CITY OF CEDAR RAPIDS
 LPO REACTOR WALKWAYS
 CEDAR RAPIDS, IOWA

FRAMING PLAN

TYPICAL DETAILS

TYPICAL GUARDRAIL AND KICK PLATE DETAIL
SCALE: NONE

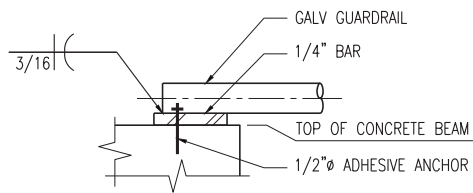
1. ~~TOP GUARDRAIL 2'-6" ABOVE WALKWAY SURFACE. MIDDLE GUARDRAIL HEIGHT TO MATCH EXISTING.~~
2. GUARDRAILS AND POSTS SHALL BE 1 1/2" DIAMETER STANDARD WEIGHT STEEL PIPE ASTM A53. GRADE B OR ASTM A501.
3. OMIT KICK PLATE WHERE KICK PLATE IS INTEGRAL WITH METAL GRATING WALKWAY.

Height of new guardrail to match the height of the existing guardrail. The top bar of the existing guardrail is approximately 40 1/2 inches.
